2025-2026 GenCost Consultation Submission

Submission to CSIRO, 2 February 2026

I welcome the opportunity to provide feedback to CSIRO and AEMO on the CSIRO GenCost 2025-26 Consultation Draft and the GHD 2025 Energy Technology Cost and Parameter Report respectively, with both reports released in December 2025. As these reports are intrinsically linked and the submission contains content that is relevant to both, the submission should be considered for both CSIRO's GenCost Consultation and AEMO's Draft 2026 Forecasting Assumptions Update Consultation.

Figure 1: Land and Development cost for key technologies selected in AEMO ISP modelling | Source: (GHD, 2025A)

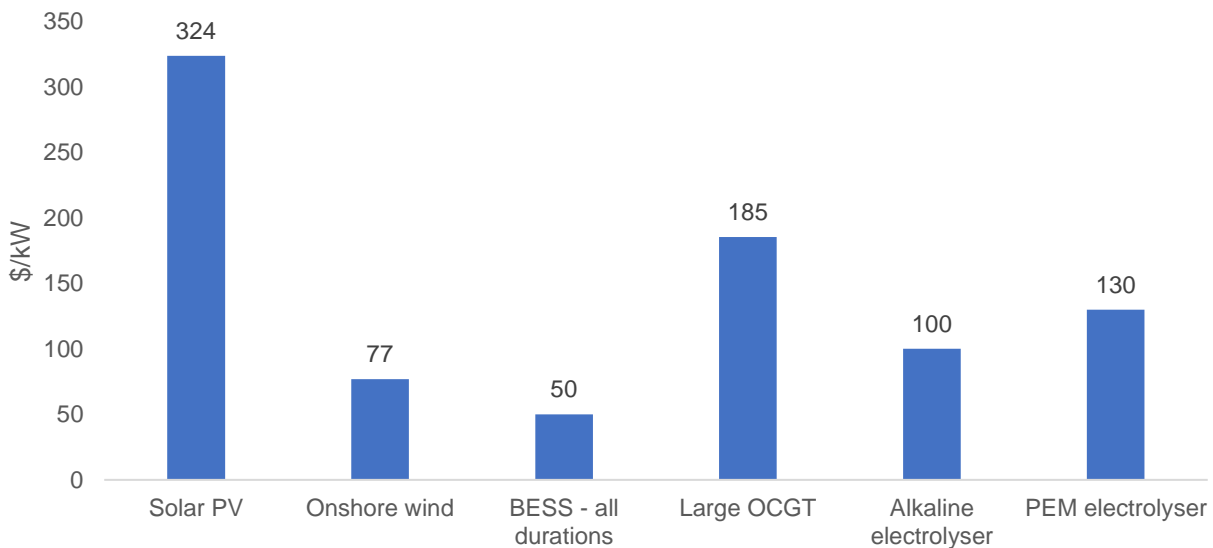
Recommendation: Provide rationale and evidence for materially reducing land and development cost for electrolysers

GHD have reduced land and development cost from 8-10% of capex (Aurecon, 2025) to 5% of capex, while also materially reducing total capex estimates. Per Figure 1 GHD assume electrolysers land and development cost per MW are materially lower than utility scale solar PV, despite the higher degree of complexity and customisation to site required for electrolyser projects (Ramboll, 2023) and likely higher land costs at industrial hub locations such as ports.

Figure 2: 2024 Electrolyser project capex estimates breakdown for detailed studies and GHD estimates, excluding connection cost and hydrogen storage (A\$/kW)

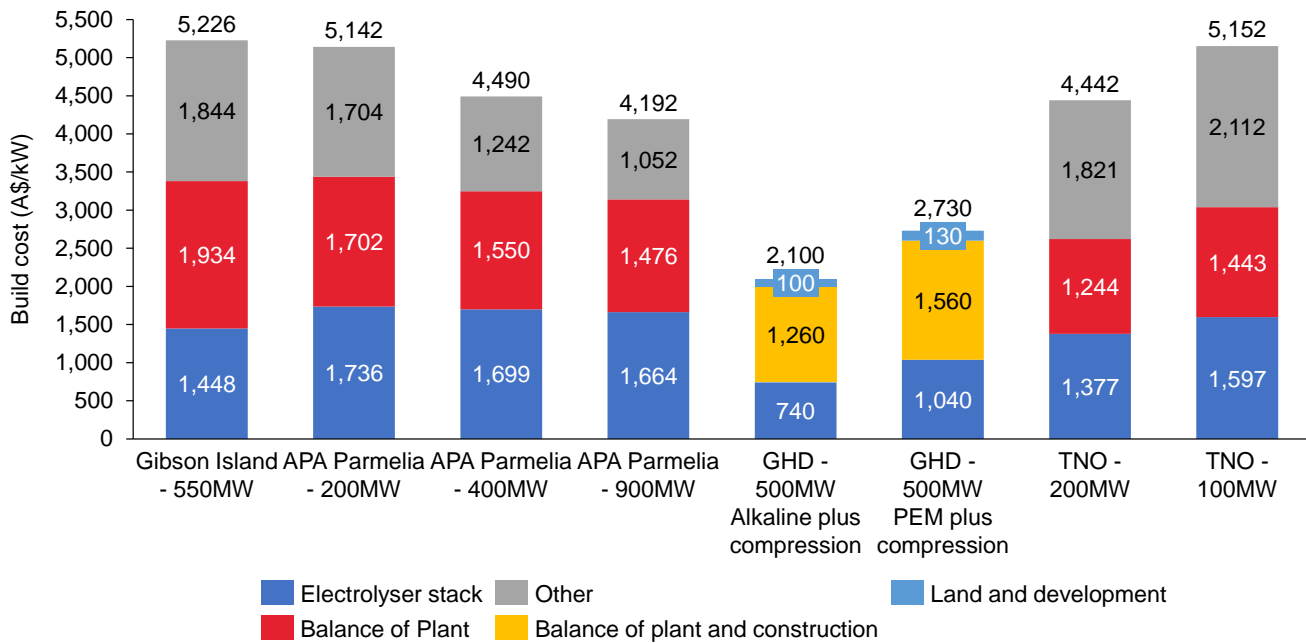
Figure 2 shows that GHD’s land and development cost estimates are materially lower than the ‘other’ category for electrolyser projects cost estimates based on detailed studies.

Figure 3: Hypothetical wind farm specific power | Source: (GHD, 2025A), various Aurecon reports

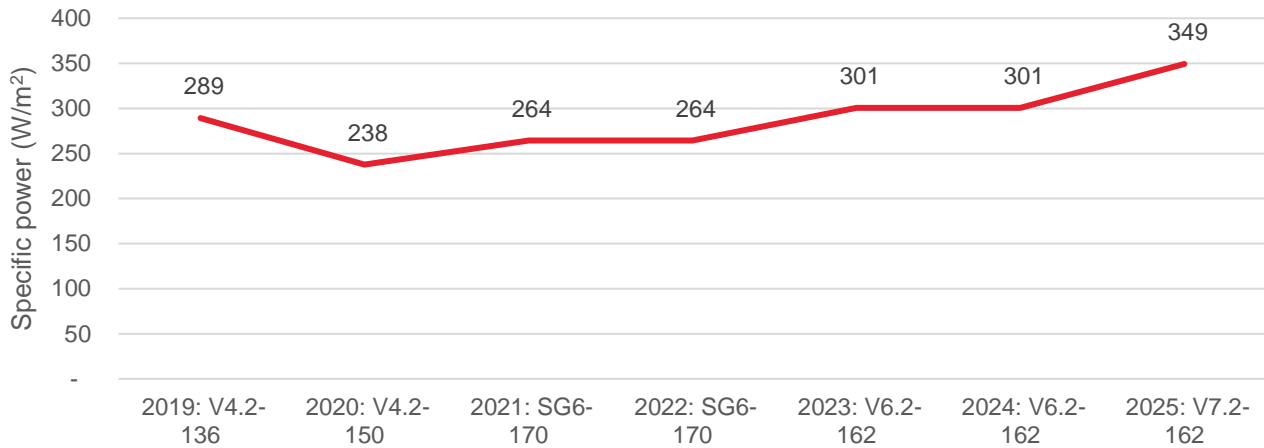
Multiple industry sources have provided feedback to the author that they haven't seen evidence supporting a reduction in onshore wind farm capex. GHD has changed the hypothetical project turbine selection from a Vestas V162-6.2MW to a Vestas V162-7.2MW. GHD's turbine selection results in hypothetical project capacity increasing 16% vs the previous Aurecon report, while build cost has decreased by 10% on a real basis, resulting in a 5% real decrease per MW. However, GHD's turbine selection results in a specific power which is inconsistent with typical NEM wind projects under development and recently reaching financial close, with this over-powering a key driver of reduced build costs per MW. For example, a lower specific power turbine such as a Vestas V172-7.2MW, has a 13% larger rotor swept area than the Vestas V162-7.2MW, resulting in higher loads on components such as towers and foundation, increasing material requirements and capex, beyond just larger turbine blades.

GHD's hypothetical turbine selection is likely to be inconsistent with AEMO's onshore wind capacity factors from the 2025 IASR. Based on typical NEM wind resources GHD's hypothetical turbine selection is unlikely to be optimal for levelized cost of energy, with over-powering resulting in lower capacity factors.

Figure 3 shows that GHD's turbine selection results in specific power of 349W/m², far higher than the 301 W/m² from Aurecon's 2024-2025 report (Vestas V162-6.2MW) and previous reports.

Recommendation: Base cost estimate on a hypothetical project with specific power similar to wind projects being developed in the NEM, such as the previously assumed Vestas V162-6.2MW turbine or a Vestas V172-7.2MW turbine.

Figure 5: Specific power of wind turbines primarily offered by turbine OEMs to Australian developers vs GHD 2025-26 Hypothetical Project

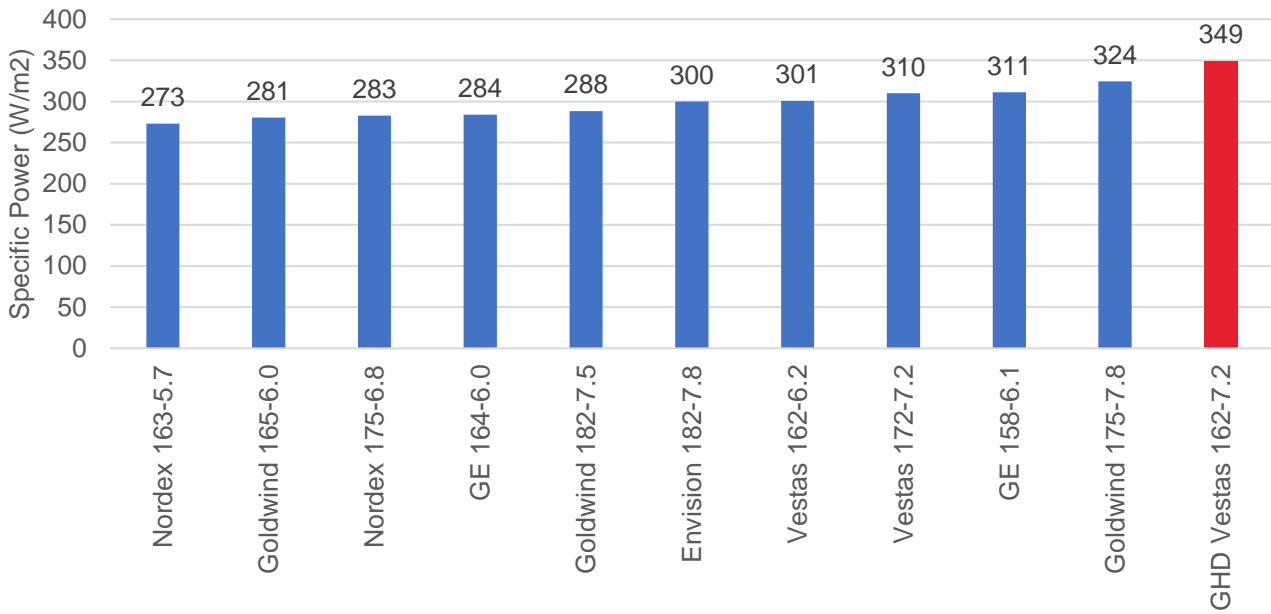
Based on market intelligence from a CAEEPR member who is active in wind farm development, Figure 5 shows that GHD's hypothetical turbine has materially higher specific power than wind turbines primarily offered by turbine OEMs to Australian developers.

Additional feedback from this CAEEPR member is that for a typical NEM wind resource a Vestas V162-7.2MW is unrealistic, with a Vestas V162-6.2MW and Vestas V172-7.2MW, likely preferable Vestas options. Vestas' 7.2MW capable EnVentus nacelle is offered with 162m and 172m rotor diameters and is a completely different nacelle design than the original Vestas V-162-6.2MW (see images from (Vestas, 2026)). To withstand the 172m rotor diameter loads it is assumed that the 7.2MW rated nacelle has higher weight and cost, which may also have implications for tower and foundations loading and capital cost. Given this higher cost and typical NEM wind speeds, a developer is more likely to pair the 7.2MW nacelle with a 172m rotor diameter, noting that as previously discussed this higher rotor swept area will likely result in increased capex.

Figure 6: Onshore Wind build cost by cost category and proportion of build cost related to Installation, Land & Development

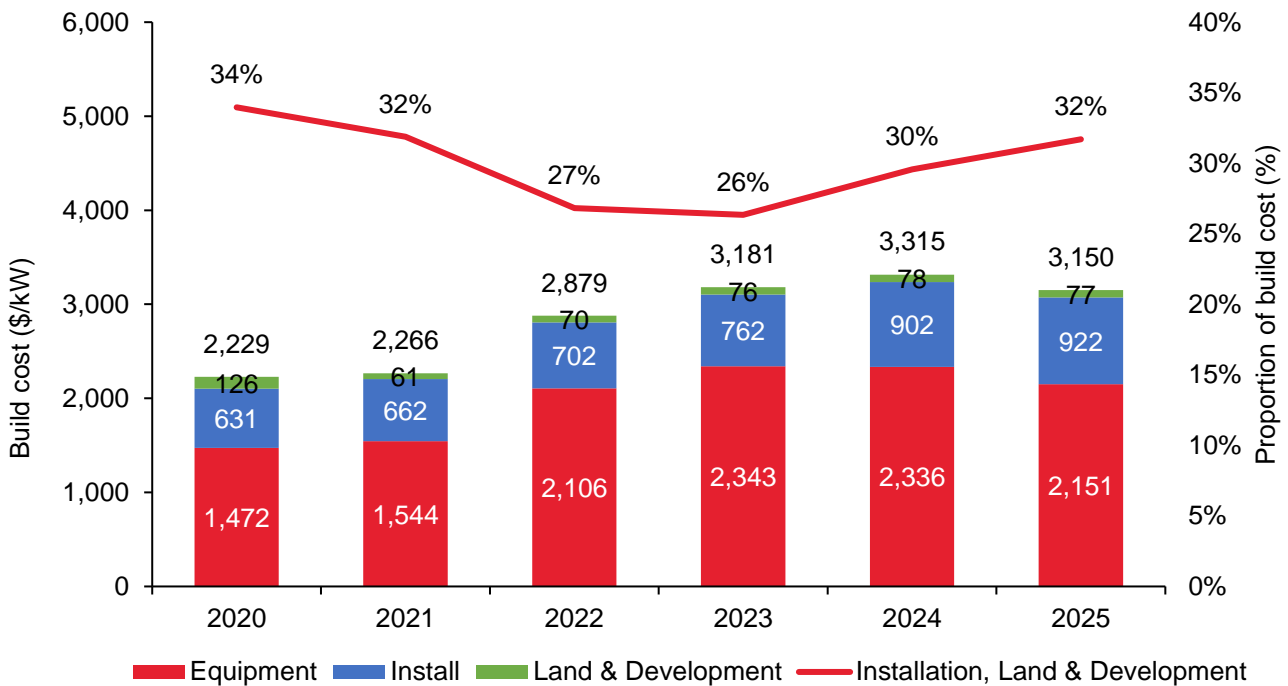
GHD commentary also states that, “simple productivity gains from larger machines and higher towers continue to open up otherwise marginal sites”, which doesn’t reflect industry experience that balance of plant and turbine installation costs have increased as turbines have scaled, as shown in Figure 6. This trend was discussed with CSIRO, Aurecon and industry experts as part of the 2024-25 GenCost consultation process.

Figure 7: Accelerated Transition electrolyser projections for CSIRO (NZE by 2050) and IEA (Net Zero Emissions) compared to BNEF and project capex estimates based on detailed studies

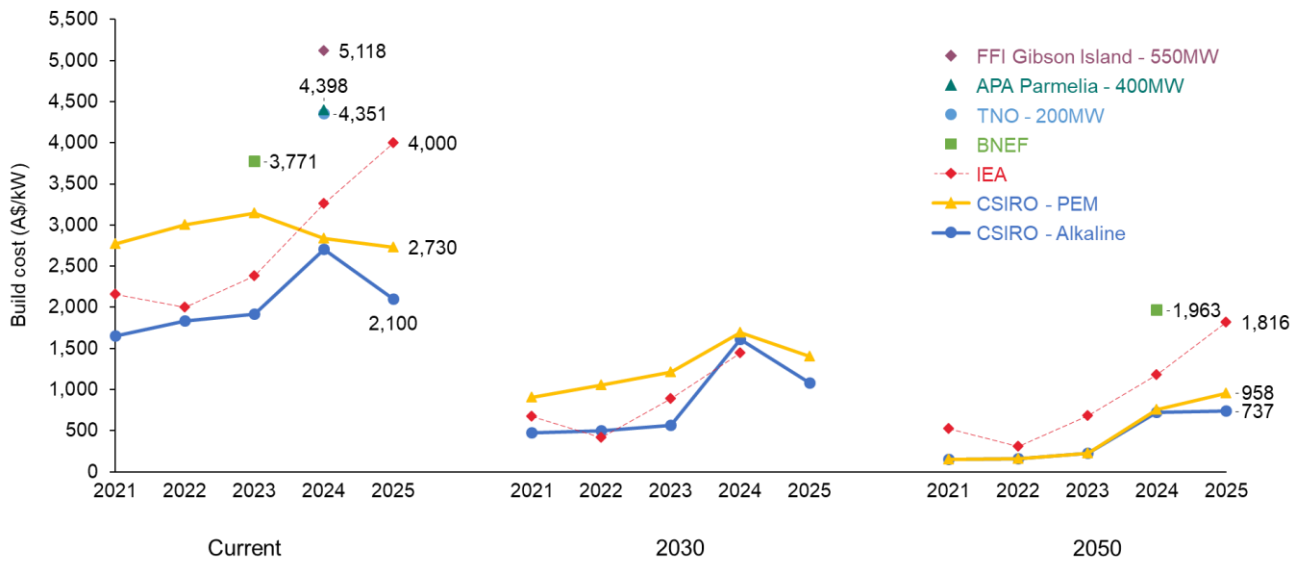
Figure 7 shows that while IEA has increased its electrolyser capex estimates ex China by 20% to be more consistent with actual projects, GHD has reduced electrolyser capex estimates by 24% for alkaline and 6% for PEM, while increasing the boundary of the capex estimate. This has resulted in GHD's alkaline estimates being around half that of IEA and BNEF and an even lower percentage of cost estimates based on detailed studies of actual projects. Given no major Australian hydrogen projects have reached financial close in recent years, GHD is encouraged to justify these substantial discounts.

Because of GHD's lower current cost estimates, CSIRO's 2050 Net Zero Emissions scenario¹ (AEMO Accelerated Transition) electrolyser capex projections are around half that of IEA and BNEF.

Recommendation: Increase build cost estimates to be consistent with detailed studies on actual projects and international benchmark data

Figure 8: Electrolyser stack as a proportion of electrolyser build cost for detailed studies, plus IEA and GHD

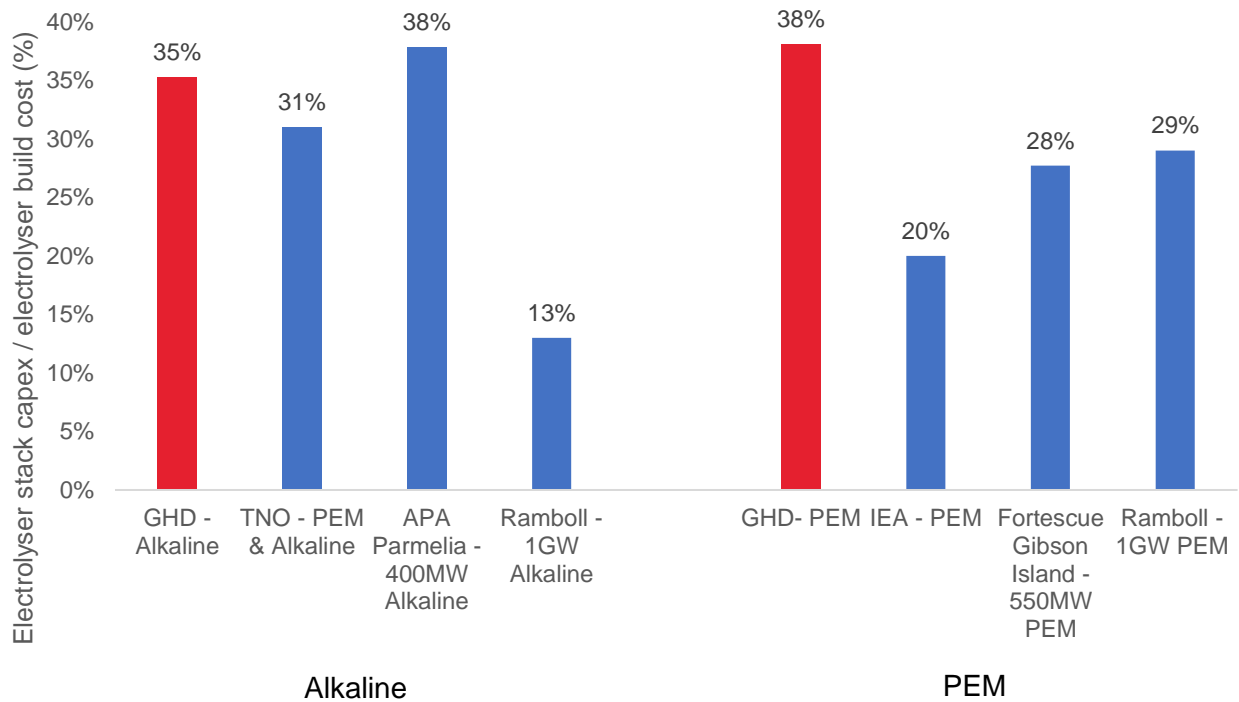
GHD includes data on the breakdown of electrolyser capex based on 2020 IRENA analysis that suggests that cell stacks represent 55% of investment cost (assumed to be \$1,200kW) for a 100MW electrolyser project. IRENA's electrolyser cost estimates and projections don't align with actual projects or international benchmarks (Siekkinen, 2024; Ramboll, 2023; Barnard, 2025; Fletcher, 2025B).

Figure 8 shows that based on reputable contemporary data sources, the electrolyser stack represents 13%-38% of build cost.

Recommendation: Estimate capital cost breakdowns on reputable, contemporary data sources

Figure 9: Tracking global green hydrogen projects announced by 2024

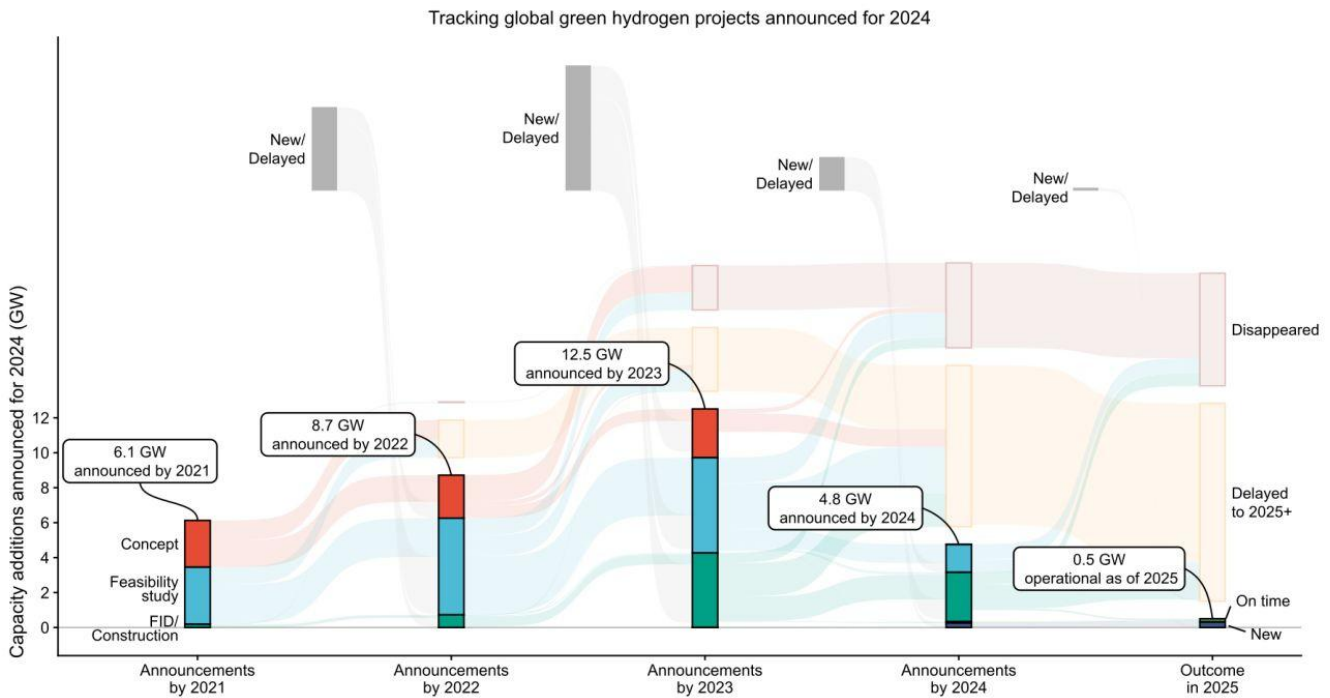
Compared to the Recent Trends section the Overview section of GHD's report lacks balance. GHD is encouraged to balance investment data from hydrogen industry peak body, the Hydrogen Council, with independent research that shows that announced hydrogen projects have failed to materialise. Research from the Potsdam Institute for Climate Impact Research (Odenweller & Ueckerdt, The green hydrogen ambition and implementation gap, 2025) found that in 2023, only 7% of announced electrolysis capacity was realised on time. Figure 9 updates this research and found that only 4% of announced electrolyser capacity was realised on time, 0.5GW instead of the 12.5GW announced just one year earlier (Odenweller, Update: What's the state of the green hydrogen market ramp-up?, 2026).

Recommendation: Reflect stalled development of hydrogen industry

Figure 10: Utility Scale Solar PV build cost by cost category and proportion of build cost related to Installation, Land & Development

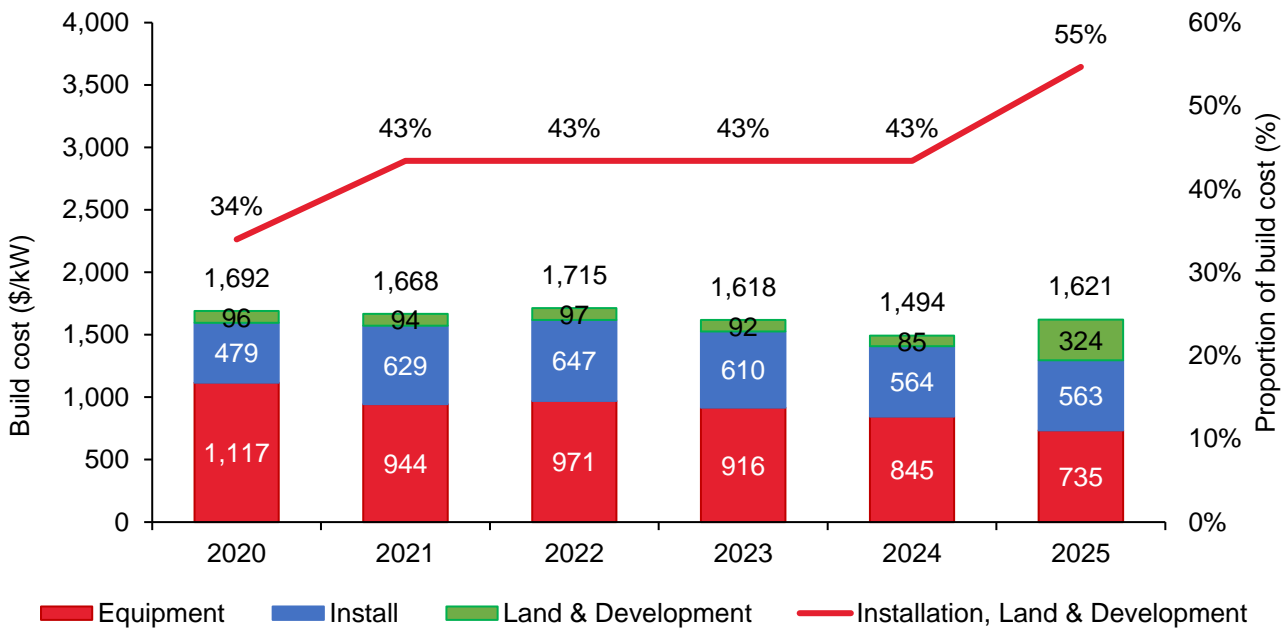
Figure 10, implies that learning may have been negative for utility scale solar PV Installation, with Land and Development cost increasing as a proportion of build cost from 34% for 2020 to 55% for 2025², a 9% pa real increase from \$575/kW or \$887/kW. While it is acknowledged that Installation cost is based on a simplistic percentage of EPC assumption, that has been sticky, and Land and Development cost have increased from 2024 to 2025 because of a methodology change, the upward trend aligns with:

- Deterioration in site quality, as best sites developed first. Site geography impacts both land and environmental offset costs, as well as installation costs.

- Environmental and planning regulation and community consultation requirements have increased development timeframes and costs.
- Increasing social licence commitments, including local content requirements. For instance the Capacity Investment Scheme is a, “*merit-based application and assessment process, including a strong weighting on community and First Nations engagement and social licence commitments, deliverability and benefit to system reliability.*” (Department of Climate Change, Energy, the Environment and Water, 2025)
- Construction escalation, which while exceeding CPI for the period (Oxford Economics Australia, 2025A) and included in CSIRO projections, is insufficient to explain the 9% real compound annual growth in Installation, Land and Development from 2020 to 2025.

Recommendation: Lower balance of system learning rate for Global NZE Post 2050
